Preferred Project Report

For:
Proposed Six Storey Commercial Building with
Two Storey Basement Car Park, Associated
Plant, Signage and Subdivision of Lot 8b

At:
8b Murray Rose Avenue,
Sydney Olympic Park

Application Number: MP10_0214

Scale	1:100 @ B1
Drawn	TS
Project No.	S11214
Status	DD
Plot Date	8/7/2011 2:34 PM
Plot File	S:\11200-11200\11214_sops_8b\02_main\cad\plot\DD\A08.02_04.dwg
Drawing No.	[Revision]

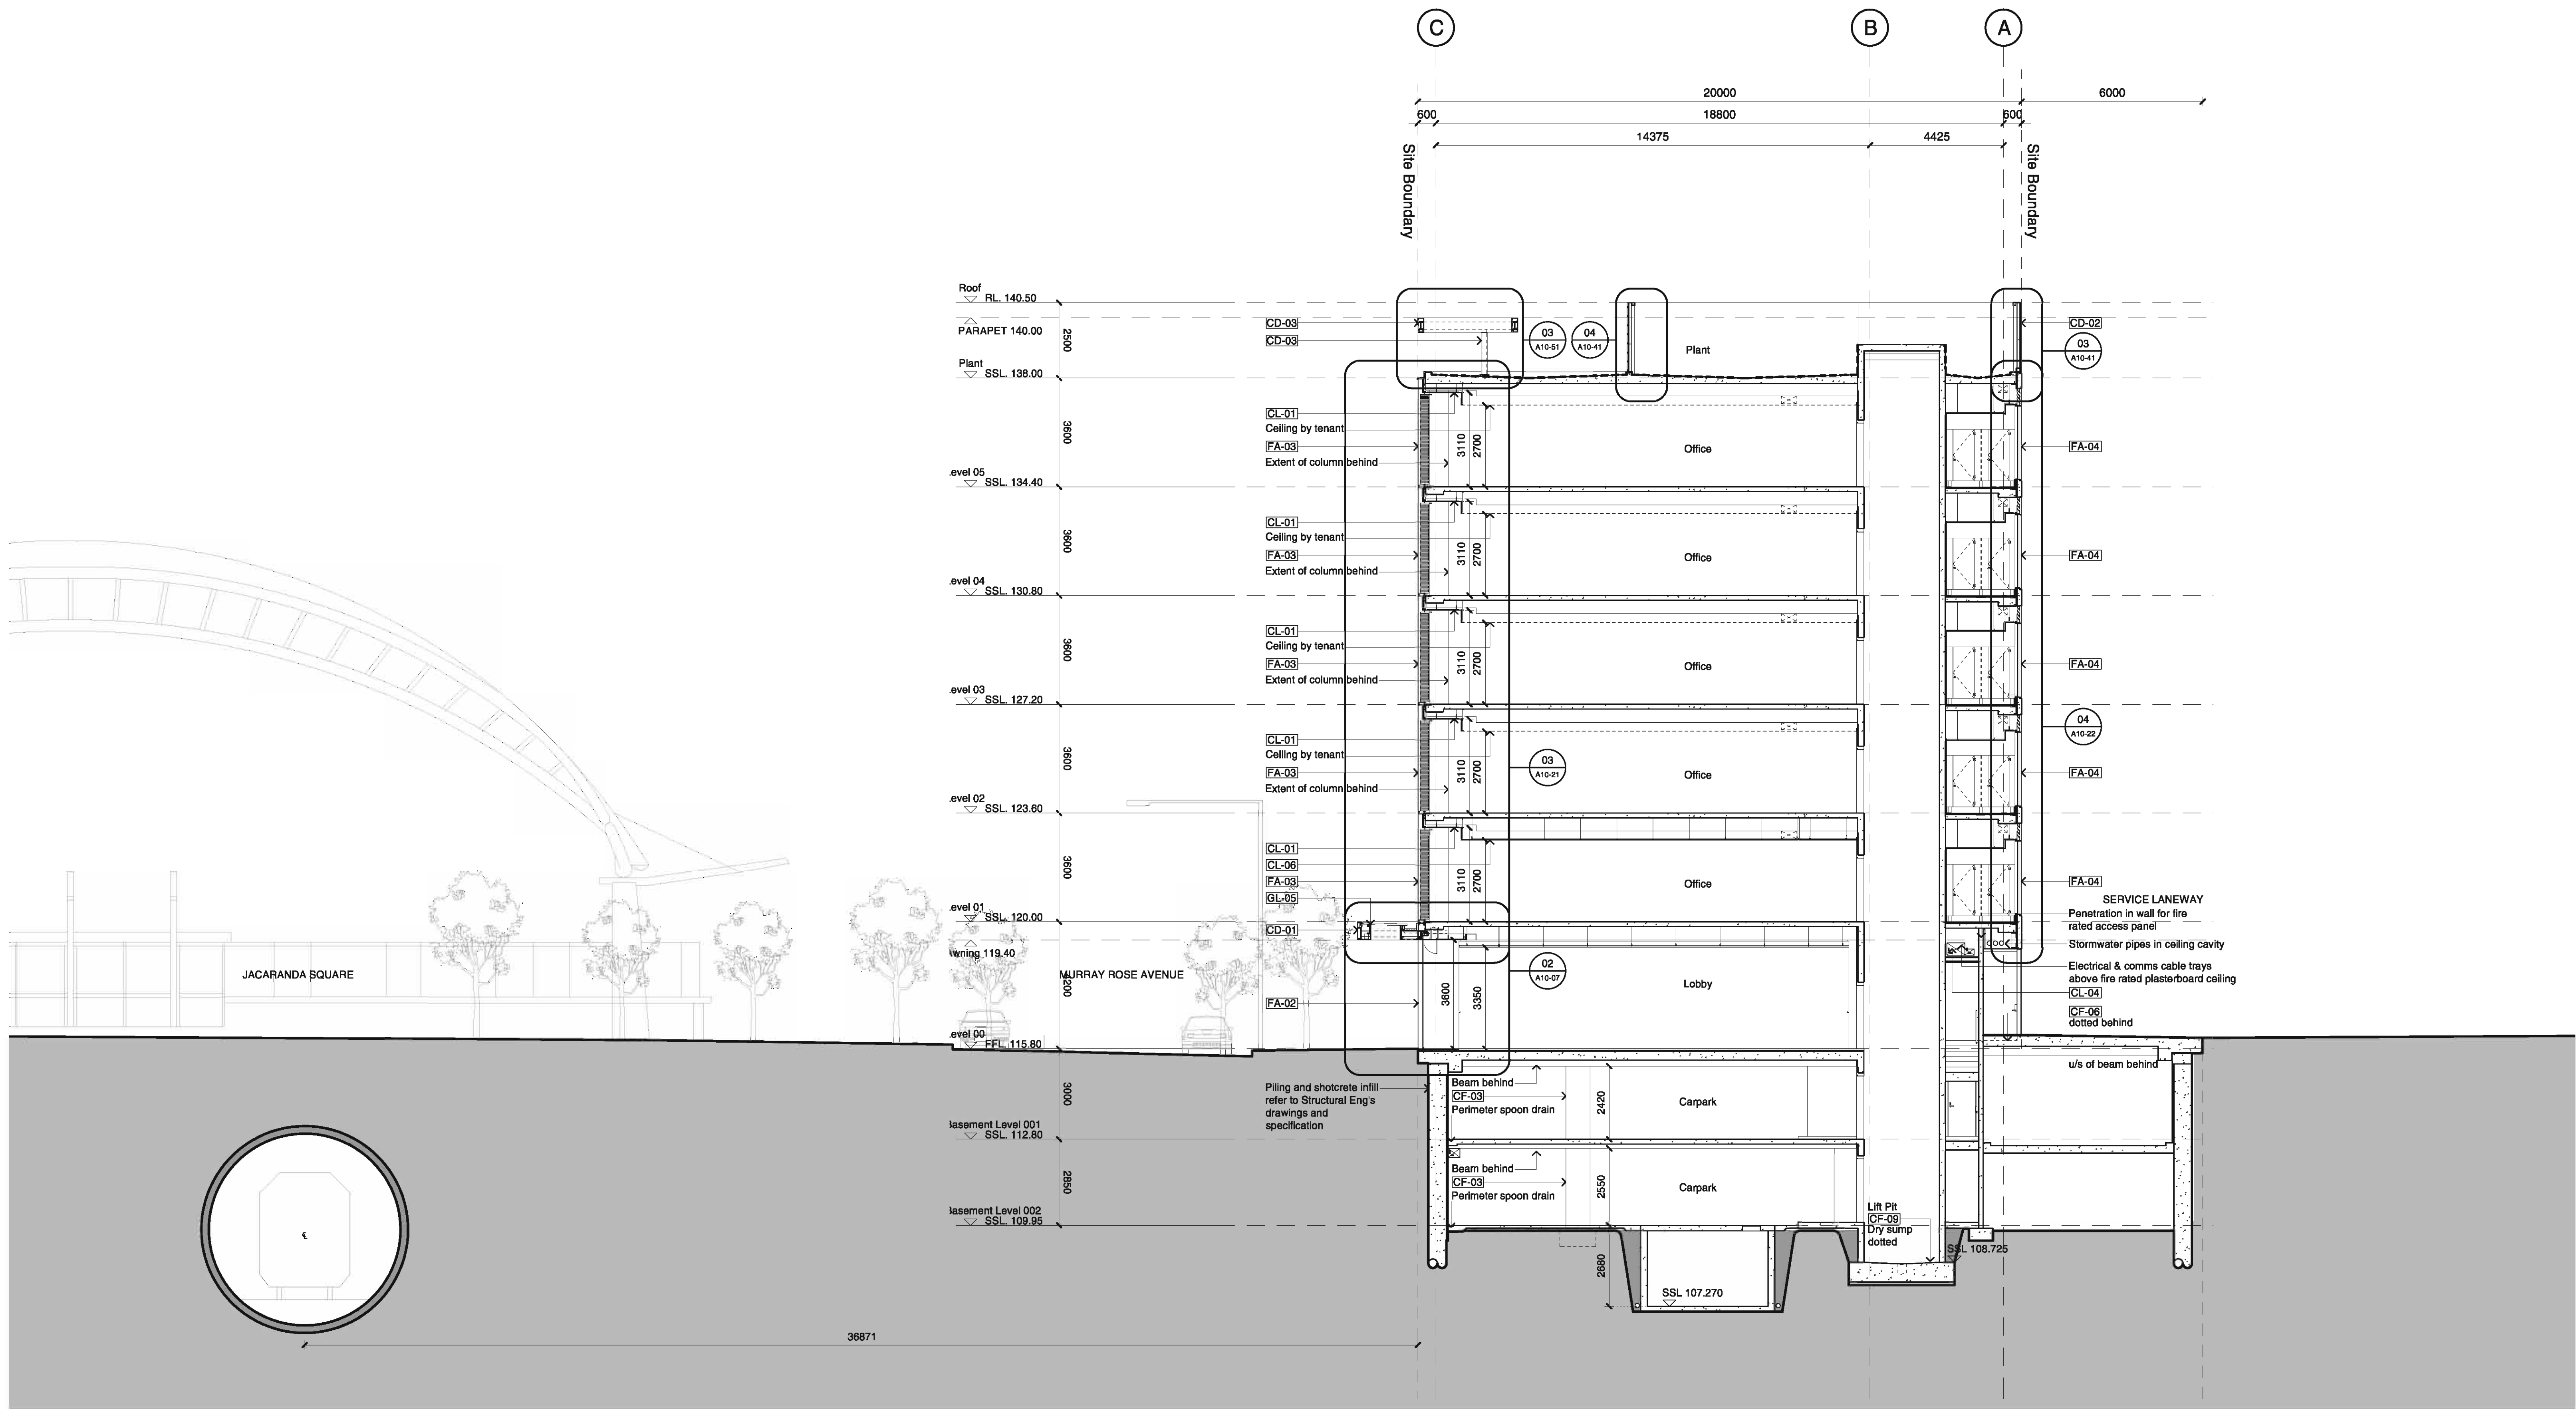
SUBMISSION ISSUES	RESPONSE
Floor to Floor Height It appears that the floor to floor height on the ground floor does not comply with MP 2030. At minimum, the clearance should be 3.3m (higher clearance is desirable). Note: Drawing No. A06.002(C) indicates an RL of 129.4 (correct RL is 119.4) to the soffit of the awning.	Floor to ceiling height on Ground Floor generally is 3.6m to the soffit of the awning and continues inside the Lobby with “see through” modular ceiling grid at 3.35m above finish floor level. It provides extended sightline to the exposed soffit at 4m from floor finish. Please refer to attached Drawing A08.02 [04].
Awnings It is noted that the awnings proposed are only 2m wide. Awnings are to be 3m width as required by MP 2030.	In response to SOPA's urban design principles and to create a unified frontage along Murray Rose Avenue ensuring consistency along the pedestrian footpath, the proposed awning is to be continuous and to match existing Site 8A in height, alignment and proportions – which is 2m wide. Widening the awning into 3m in width will create a break and inconsistency along pedestrian footpath. The urban design principles won't be achieved as the scale and continuity along footpath do not match existing awning. We strongly recommend the proposed awning to match existing Site 8A, which is 2m in width.

Floor to ceiling height on Ground Floor generally is 3.6m to the soffit of the awning and continues inside the Lobby with "see through" modular ceiling grid at 3.35m above finish floor level. It provides extended sightline to the exposed soffit at 4m from floor finish. Please refer to attached Drawing A08.02[04].
